# Broward County Board of Rules and Appeals Meeting Agenda

September 11, 2025 | Time: 7:00 PM

Part 1: Basis to Appeal Town of Davie Building Official William Diaz's Determination that The Permit plans called for wood trusses and the related determination of compliance with certain sections of the Florida Building Code which governs wood trusses

Subject: Response to Appeal Regarding the Certificate of Compliance denial – Permit number 2024-00006024, Project address, 9411 Live Oak Place, Davie, FL 33324.

4 ROOF FRAMING  
 S-2 N.T.S.

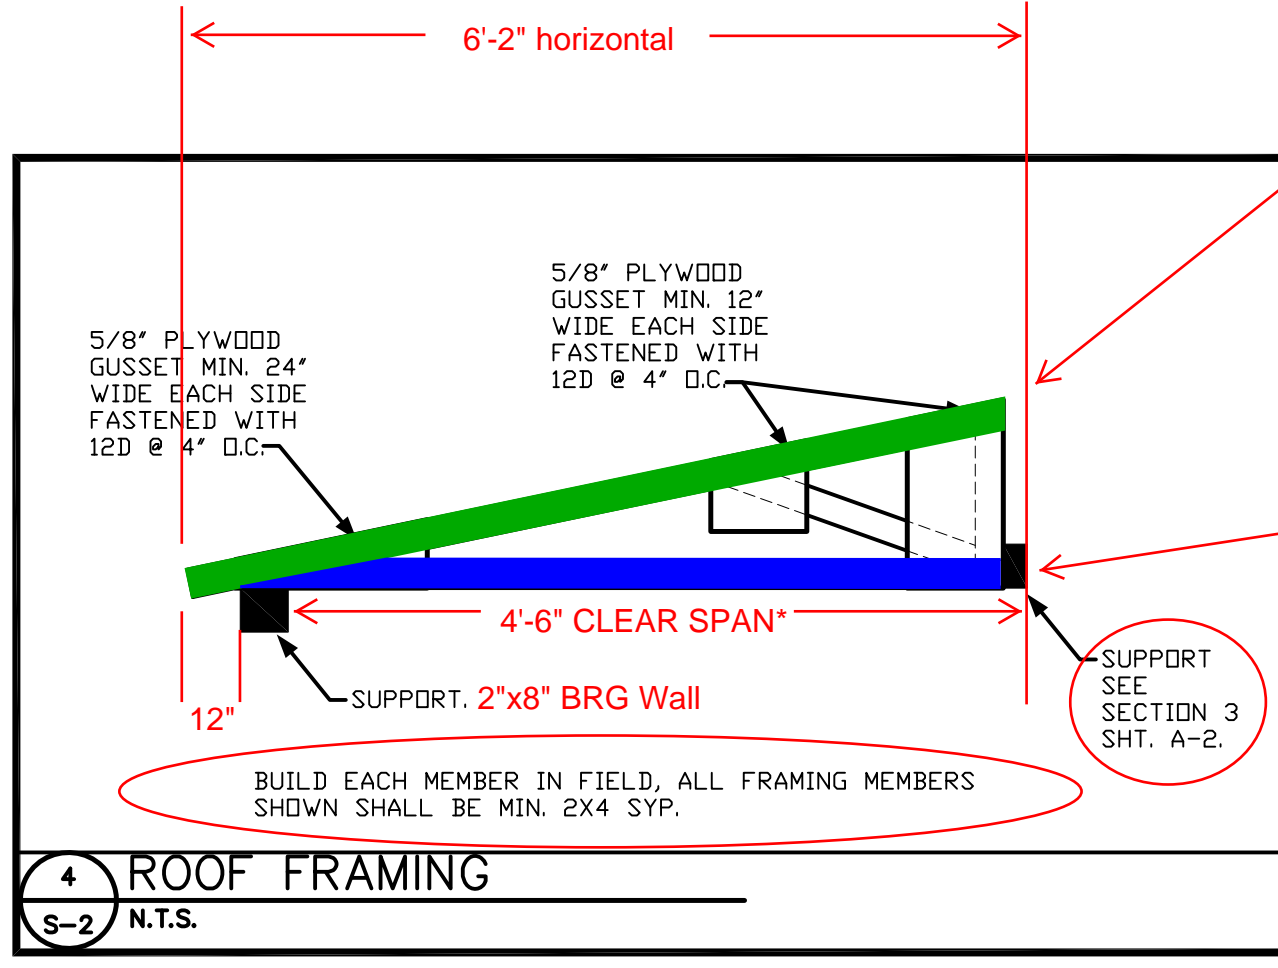
The truss system shop drawings were not submitted by a delegated engineer, as required. Instead, truss details were provided by a registered architect (Sheet S-2), which does not meet the specific requirement that designs for individual trusses be prepared and sealed by a licensed engineer.

Construction documents lacked sufficient clarity and did not demonstrate compliance with HVHZ provisions. Sheet S-2, detail 3, references a lateral bracing detail for pre-engineered trusses, but this alone does not satisfy the requirement to include

Roof framing plans failed to indicate uplift forces, live and wind load per Chapter 16. This level of detail is necessary to verify that the roof structure can resist expected wind loads.

Roof-to-wall anchors provided in the S-2 sheet anchor schedule are not approved for roof trusses to wood walls. See the anchor manufacturer detail provided attached.

- The Permit plans provide sufficient detail for the roof framing system, including but not limited to, specifying 2x4 Southern Pine dimension lumber for roof framing members and further specifying to "BUILD EACH MEMBER IN FIELD", see detail 4 sheet S-2, see Exhibits 'A' & 'G'.

- Sheet S-2 of The Permit shows the roof framing configuration and other important details required by FBC-B 2023 section 2319.10. Importantly, detail 4 on sheet S-2 details the construction of the roof framing members by utilizing 2x4 Southern Pine dimension lumber and said detail clearly specifies to "BUILD EACH MEMBER IN FIELD", which means the Contractor shall furnish this work, this work is NOT designed and furnished by others. Based on a plain reading of the text in The Permit plans, premanufactured wood trusses shall NOT be used for this roof. Reference sheet S-2 in Exhibits 'A' and 'G'.
- FBC-B 2023 table 1607.1 requires a minimum roof Live Load of 20 PSF for the type of roof specified in The Permit because, in this case The Permit roof is a non-occupiable pitched roof (with shingles). Reference highlighted sections of Exhibit 'B'.

- Detail 4 on sheet S-2 of Exhibit 'G' graphically depicts a distinct roof rafter (shown in green) and a distinct ceiling joist (shown in blue) both of which are overlaid onto the roof framing member shown at detail 4 of The Permit plans. Additionally, dimensions, spans and certain aforementioned notes are also overlaid onto said detail 4 of sheet S-2 Exhibit 'G'. As detailed above and according to 2023 FBC, the roof rafter specified as a 2x4 Southern Pine on detail 4 sheet S-2 of Exhibit 'G' is sufficient (by itself and without support from additional members) for its intended use under the conditions and design contemplated in The Permit. Furthermore, as detailed above and according to 2023 FBC, the ceiling joist specified as a 2x4 Southern Pine on detail 4 sheet S-2 of Exhibit 'G' is sufficient (by itself and without support from additional members) for its intended use under the conditions and design contemplated in The Permit. In fact, because The Permit actual rafter span is 65% of the maximum allowable in 2023 FBC and because The Permit actual ceiling joist span is 44% of the maximum allowable in 2023 FBC, each member as specified and constructed has a factor of safety over and above that which has already been incorporated into the span tables. Stated differently, a single 2x4 roof rafter and a single 2x4 ceiling joist specified in The Permit, each by itself, exceeds the minimum applicable standards in 2023 FBC.

- Although the above demonstrates that a single 2x4 roof rafter and a separate 2x4 ceiling joist (each by itself) exceeds the minimum requirements of 2023 FBC, the AOR choose to further increase the strength of the design by specifying 2x4 roof framing members in addition to the single rafter and ceiling joist thereby far exceeding the minimum requirement of 2023 FBC. The AOR's choice to far exceed the minimum standards in 2023 FBC does not transform the design into something different than the clear wording shown on The Permit plans which was "BUILD EACH MEMBER IN FIELD", i.e. the roof framing specified by the AOR is NOT a wood truss.

Rafter not supporting ceiling in green.  
 A single 2x4 SP as specified is adequate per AWC STJR Table R-19. Stated differently, this single 2x4 member (by itself and without other support or additional framing members) can exist on its own and meet the plain wording of all applicable sections of FBC-B 2023.

Ceiling joist supporting only drywall in blue.  
 A single 2x4 SP as specified is adequate per AWC STJR Table C-1. Stated differently, this single 2x4 member (by itself and without other support or additional framing members) can exist on its own and meet the plain wording of all applicable sections of FBC-B 2023.
